We request that you amend US Nuclear Regulatory Commission License Number SUC-1593 (docket number 040-9083) to correct the location of the Radiation Control Area at Donnelly Training Area, Fort Wainwright, Alaska.

We have enclosed "M101 Impact Areas," dated February 16, 2018, which should replace a similar document dated December 31, 2015 that is currently incorporated in the license by reference. The only change to "M101 Impact Areas" is the map on page 2.

SUBJECT: Request for Administrative Adjustment to Installation Specific Archive Search
Report on the Use of Cartridge, 20mm Spotting M101 Davy Crockett light Weapon M28 at
Fort Greely, Alaska, October 2008

SUBJECT: Analysis to Support Administrative Adjustment to Installation Specific Archive Search Report on the Use of Cartridge, 20mm Spotting M101 Davy Crockett light Weapon M28 at Fort Greely, Alaska, October 2008

REVISION TO PLATE 5

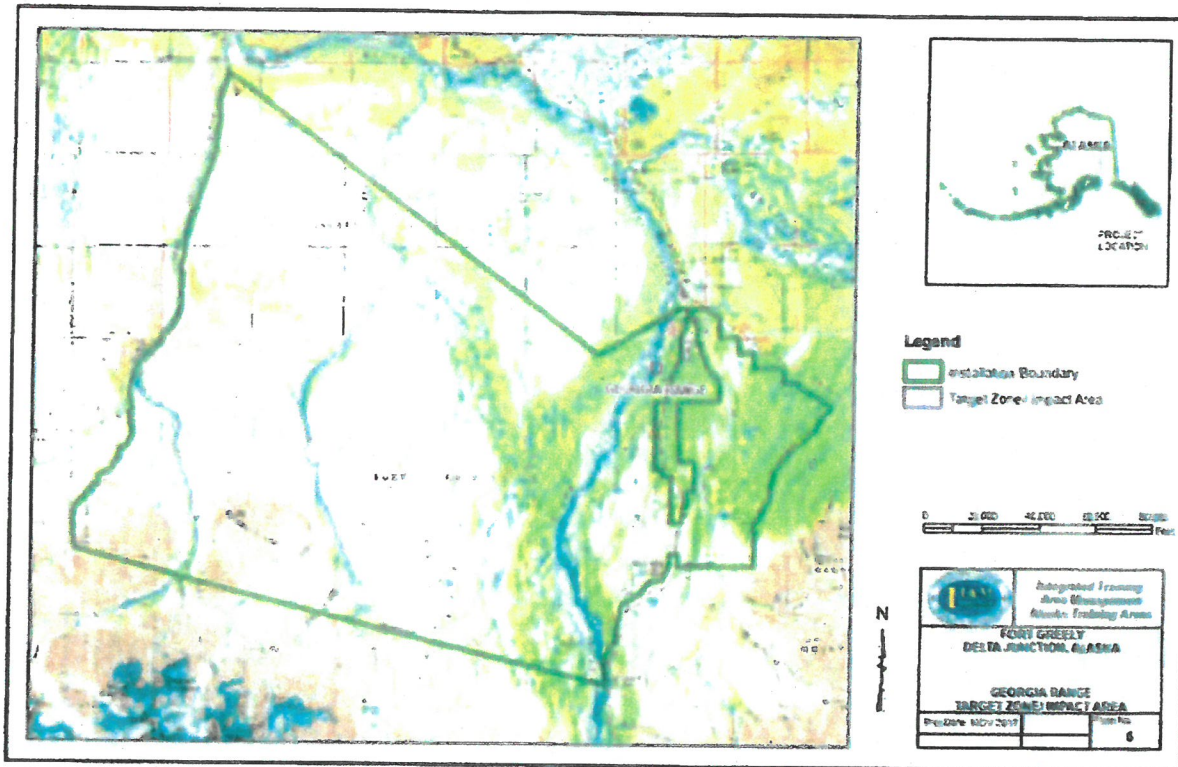
n. Enclosures 14 – 19 are the revisions to the plates in Appendix I of the report based on the corrected version of the SDAD. The specific changes to the LAT/LONG for the corrected box are listed as well as on the diagram.

REVISION TO PLATE 6

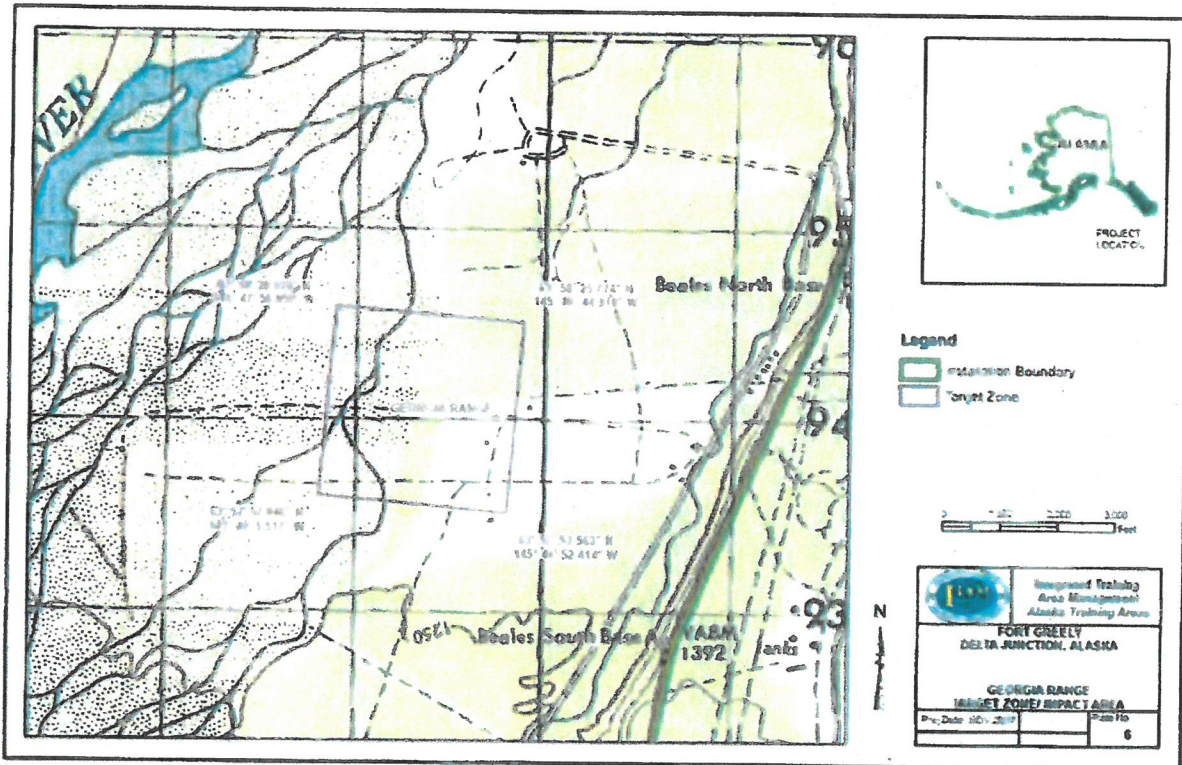
FT GREELY SDAD CORRECTED LAT/LONG

POSITION	ORIGINAL REPORT (OCT 2008)		REQUESTED CORRECTION	
	LATITUDE	LONGITUDE	LATITUDE	LONGITUDE
NW	63° 58' 30.561" N	145° 47' 48.533" W	63° 58' 28.976" N	145° 47' 58.059" W
NE	63° 58' 27.721" N	145° 46' 35.305" W	63° 58' 25.774" N	145° 46' 44.910" W
SE	63° 57' 55.475" N	145° 46' 41.983" W	63° 57' 53.563" N	145° 46' 52.414" W
SW	63° 57' 58.596" N	145° 47' 55.171" W	63° 57' 57.046" N	145° 48' 5.517" W
